**Hermosa Project  
Aquifer Protection Permit OTHER Amendment Application  
P-512235**

**SANTA CRUZ COUNTY, ARIZONA**

Re: Aquifer Protection Permit Other Amendment P-512235  
Hermosa Project Trench Camp

**Water Treatment Plant Upgrades and Modifications**

Figure 2-1: As-Built WTP Block Flow Diagram

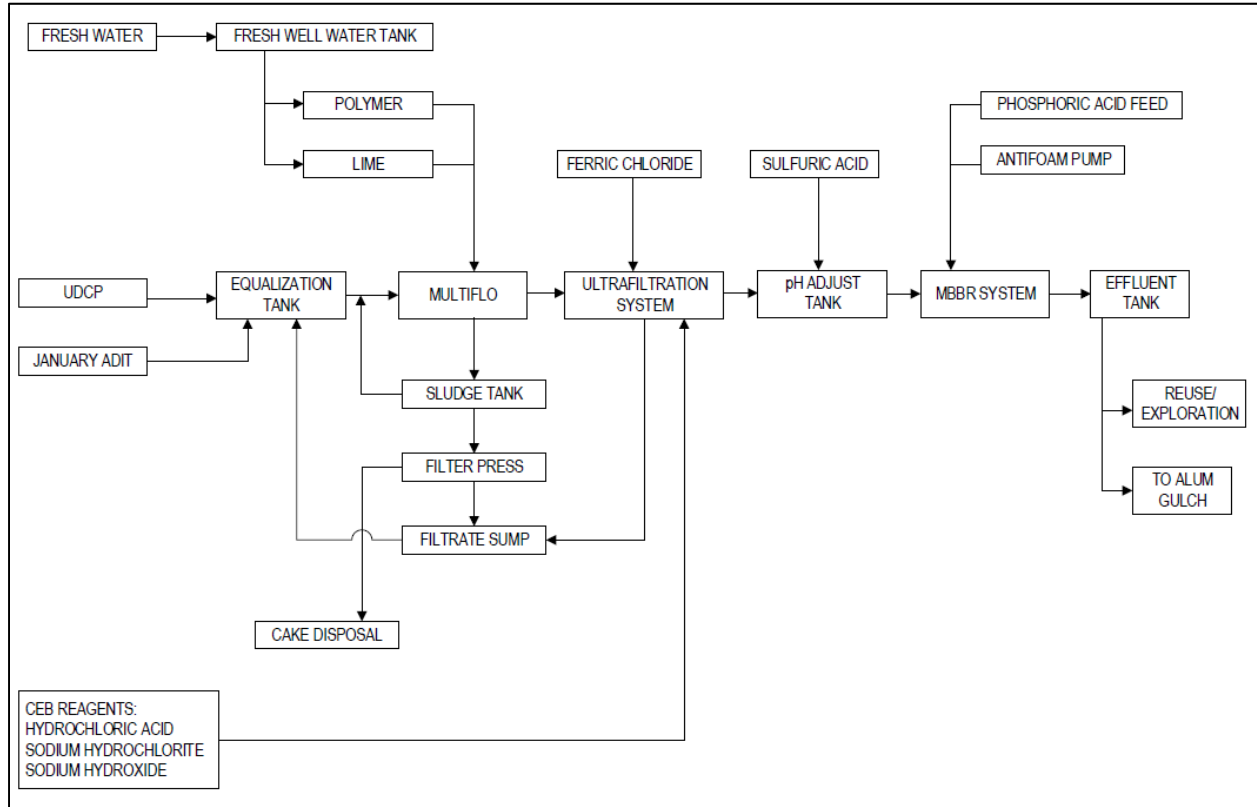
The treatment process for the as-built WTP to treat 100% January Adit, 100% UCP or any combination of both waters is summarized as follows and depicted in the block flow diagram shown in Figure 2-1:

**Figure 4-1: Block Flow Diagram for Upgrades to WTP – for Sulfate and Selenium Reduction**

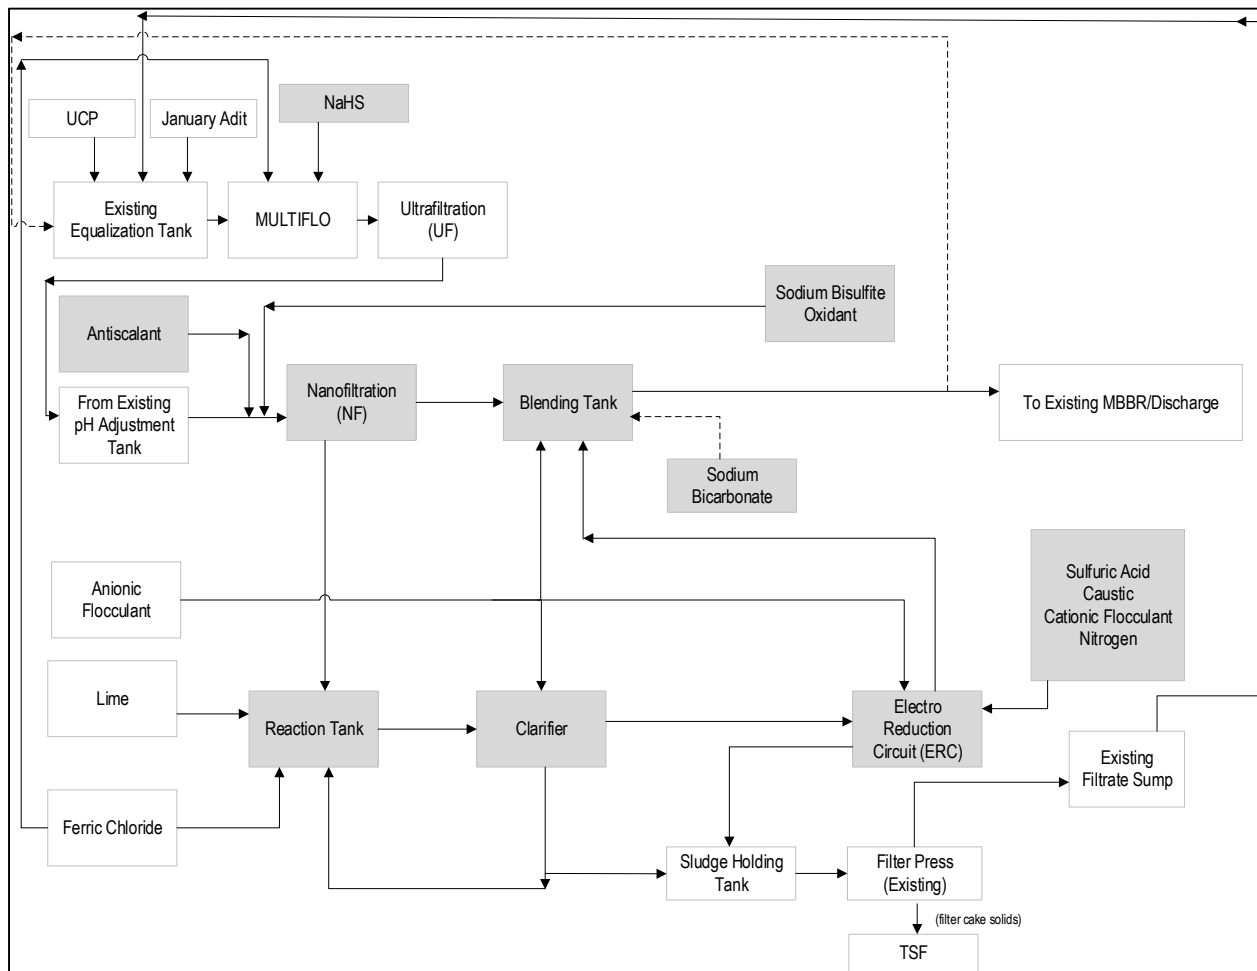
The upgrades proposed for the WTP to treat for excess sulfate and selenium are summarized below and are depicted in the block flow diagram shown in Figure 4-1.

- Raw water will be treated primarily with sodium hydrosulfide (NaHS) to precipitate metals at the MULTIFLO™ rather than lime. Switching to soluble sulfide addition at this stage of the process serves to reduce scaling, membrane fouling and reagent consumption. Lime addition at the MULTIFLO™ will be intermittent on an as needed basis for pH adjustment.

- After processing the raw water through the existing MULTIFLO™ and UF skid of WTP, neutralized filtered water at the existing pH adjustment tank will be diverted to a new NF unit.

Figure 4-2: Overall Site Plan

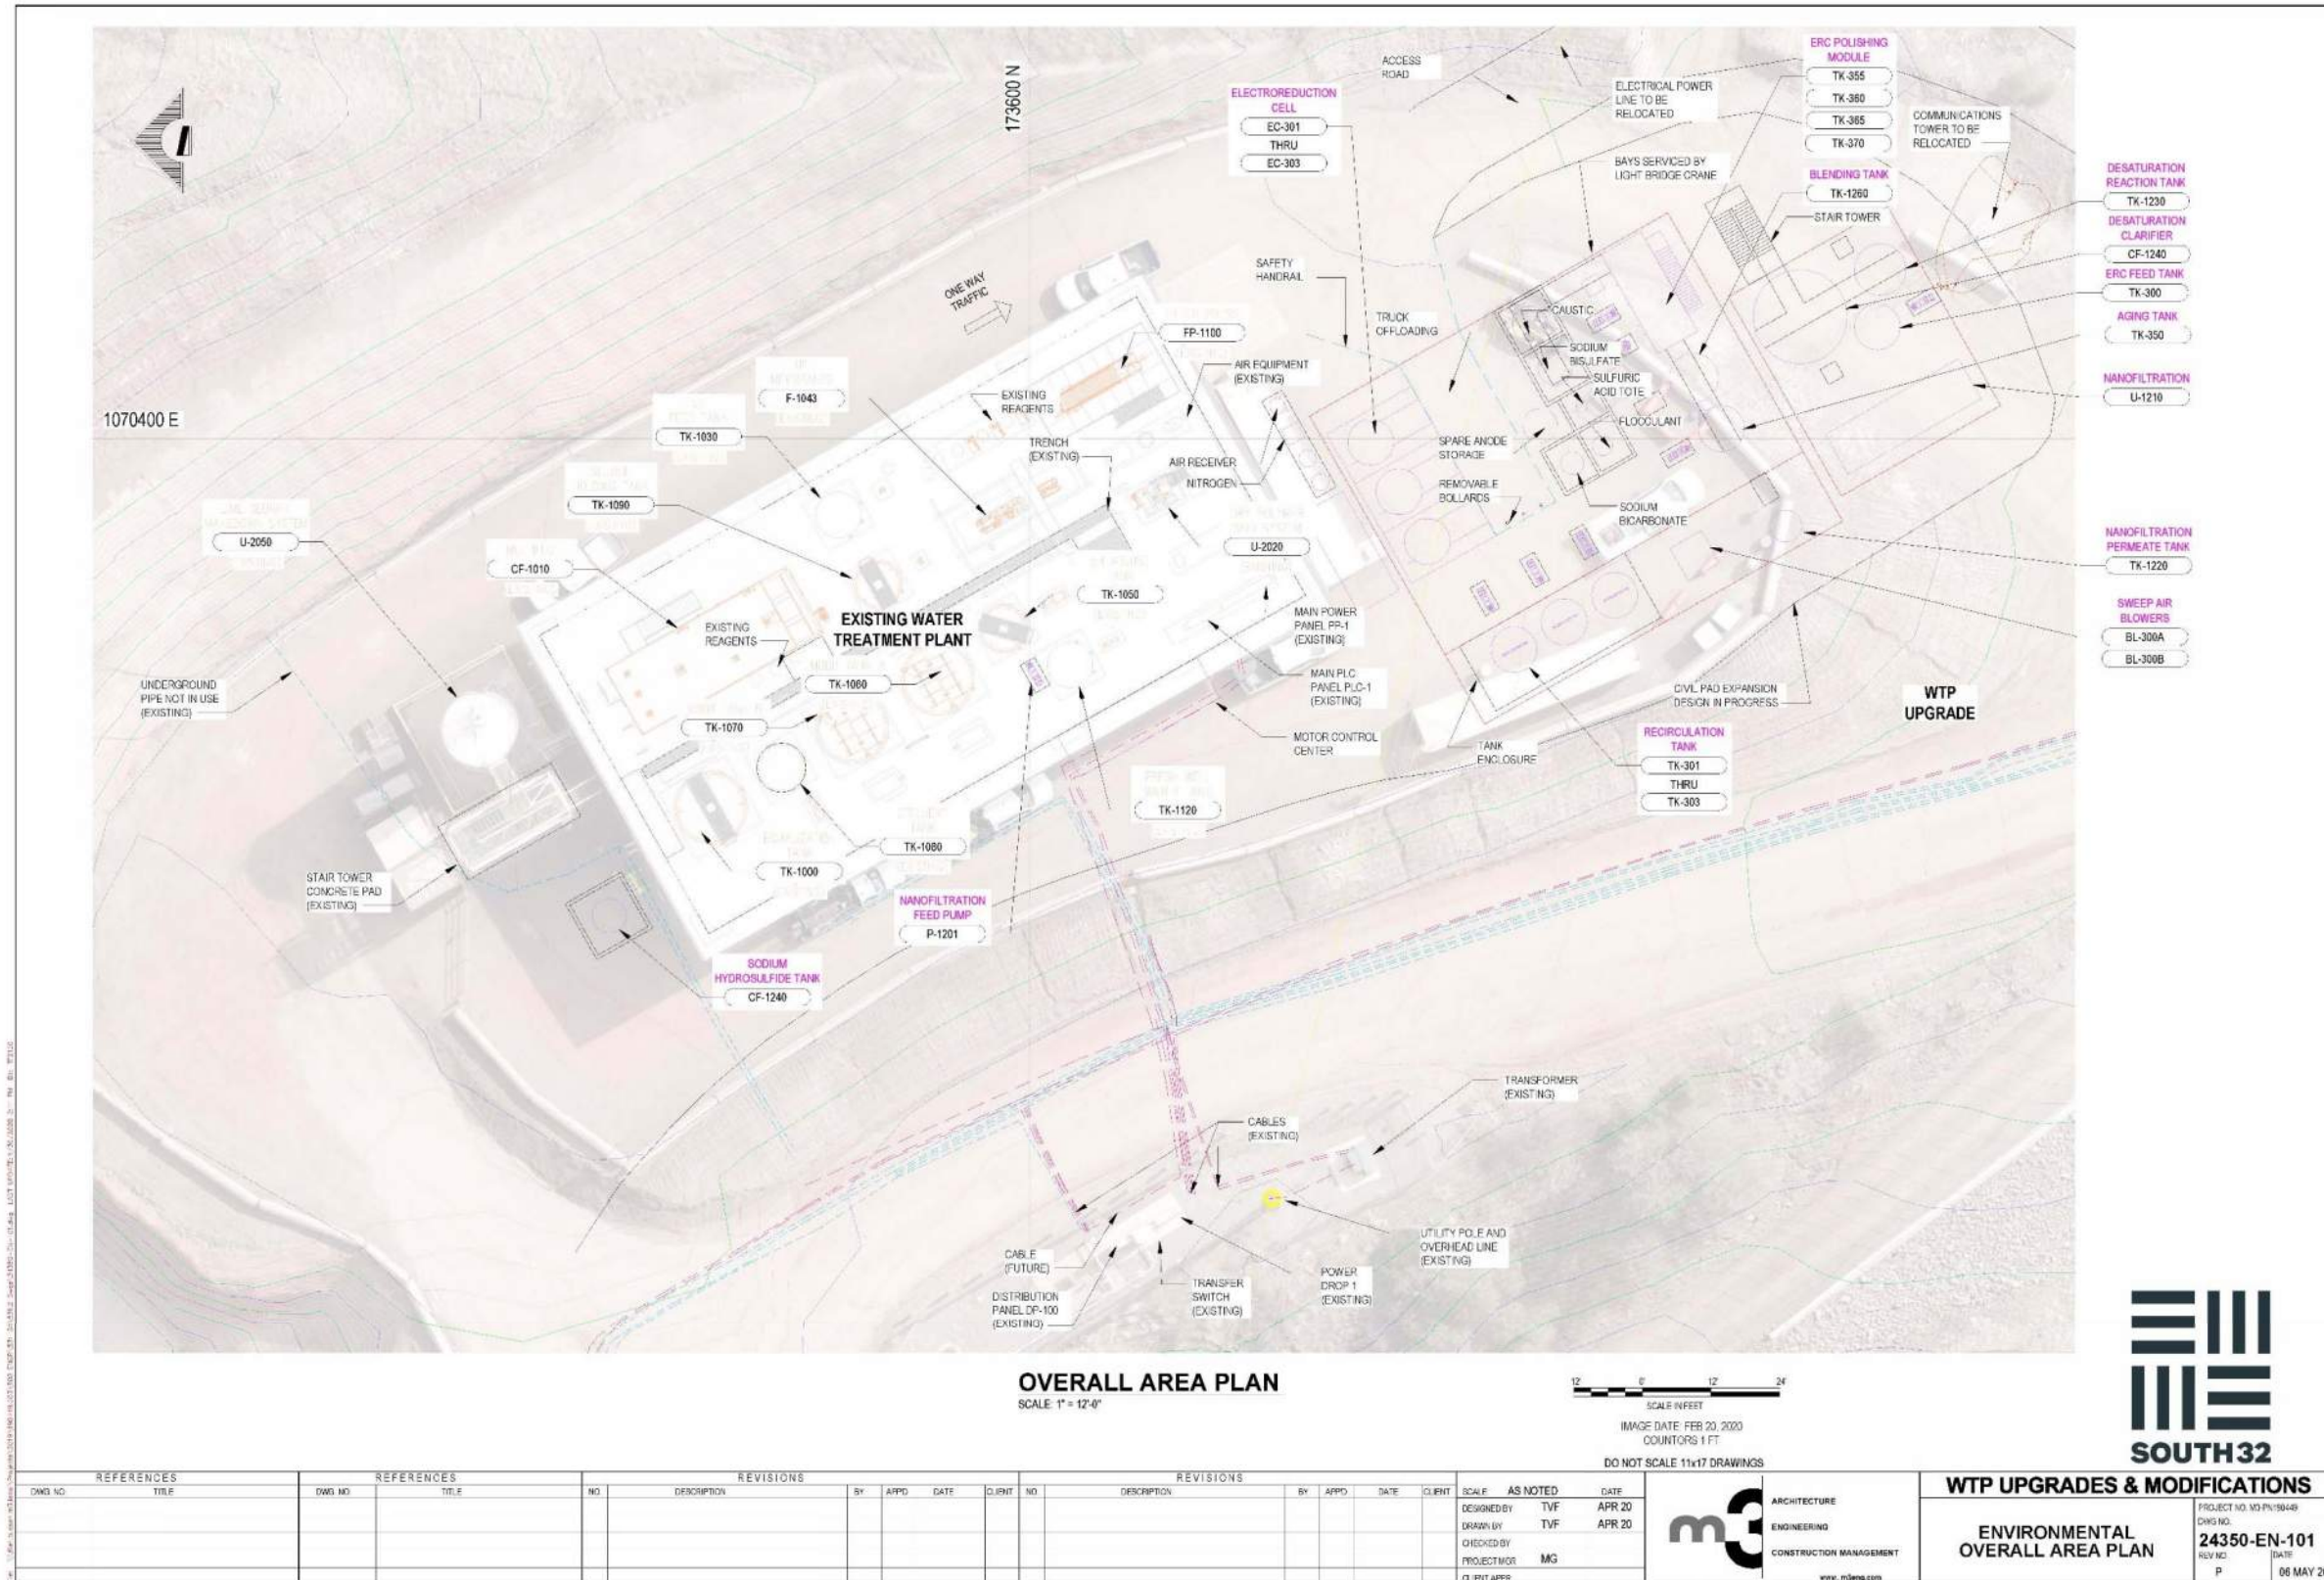
The footprint of the proposed upgrade to WTP shown in Figure 4-2 is immediately south of the existing plant and covers approximately 5,800 square feet. The upgrades to the WTP will tie directly into the existing plant as shown in the General Arrangement presented in Appendix J.

**NOTE:**  
 1. REFER TO TECHNICAL SPECIFICATIONS FOR AREA SPECIFIC PLACEMENT ZONES FOR WTP FILTER CAKE AND CORE CUTTING MATERIALS.

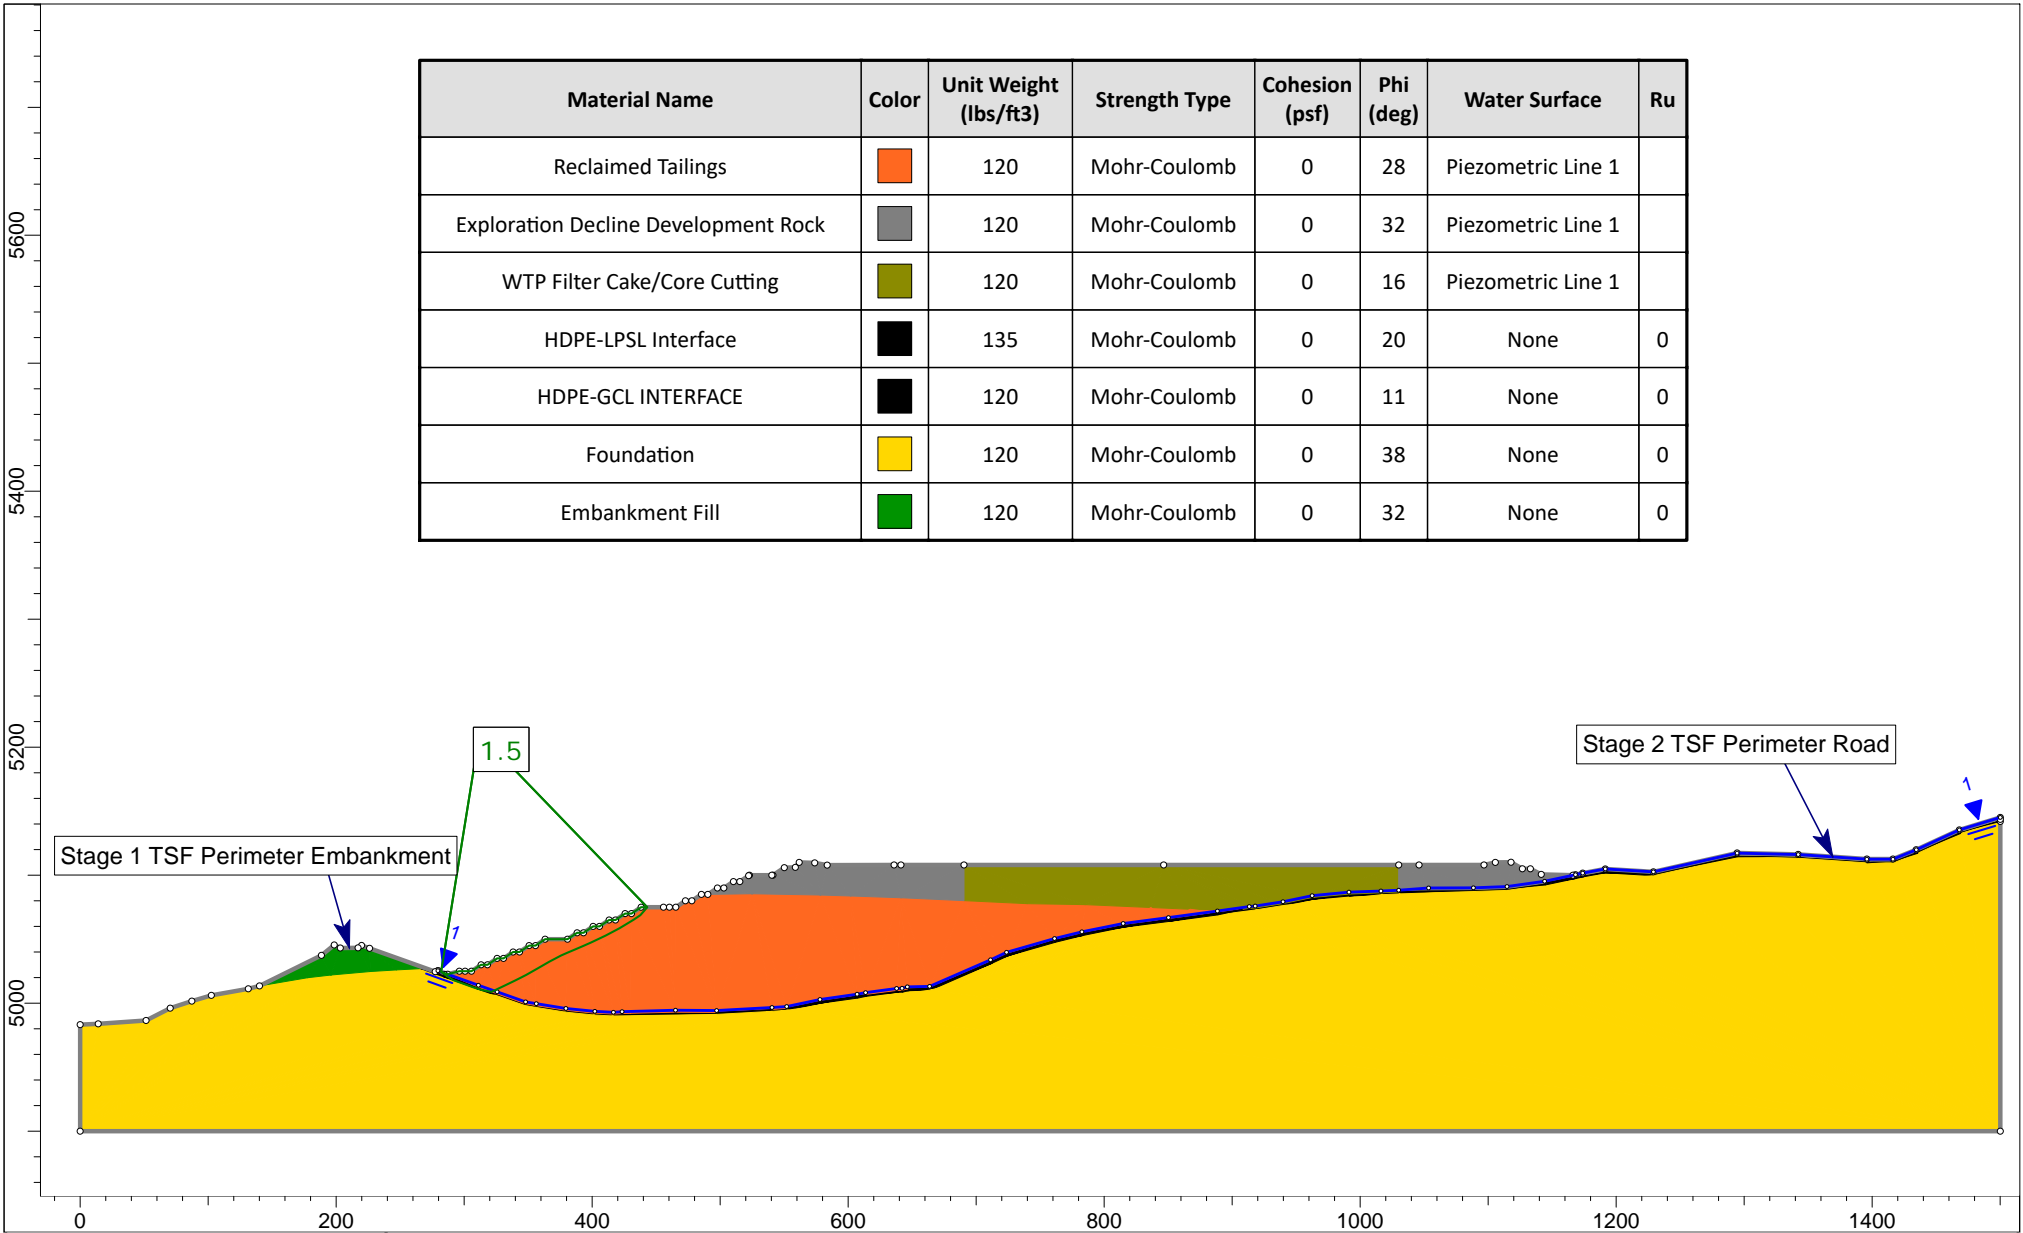
WTP filter cake material placement shall occur only in the area shown on Figure 1 (attached). To the greatest extent possible, filter cake material placement shall not be in one continuous area or layer. Placement of each load of filter cake material shall be spread out so that distance between each placement area is maximized. Placement of filter cake material shall be temporarily suspended due to weather concerns if the materials and installation cannot comply with the guidance parameters stated above.

Core cutting material placement shall occur only in the area shown on Figure 1 (attached). To the greatest extent possible, core cutting material placement shall not be in one continuous area or layer. Placement of each load of core cutting material shall be spread out so that distance between each placement area is maximized. Placement of core cutting material shall be temporarily suspended due to weather concerns if the materials and installation cannot comply with the guidance parameters stated above.
